Delegated Report

Householder Planning Application

Planning Application No: 20231244

Description: Creation of a vehicular access with hardstanding.

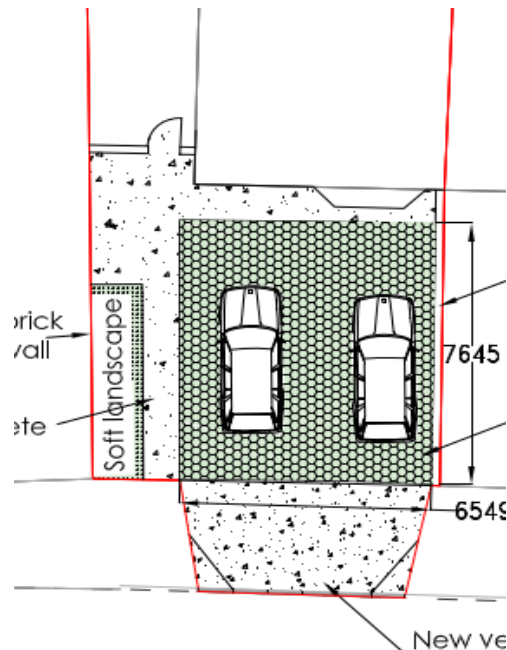
The vehicle crossover and associated hardstanding area will be constructed using permeable paving. The parking area has a 6.55m width by a 7.65m depth which provides sufficient space to comply with the requirements of SPG4. The proposed crossover would also measure 6.55m wide and 3.2m in depth.

Whilst there is some soft landscaping proposed within the garden frontage, it is not generally considered to be an acceptable amount to sufficiently soften the overall appearance of the development and provide biodiversity.
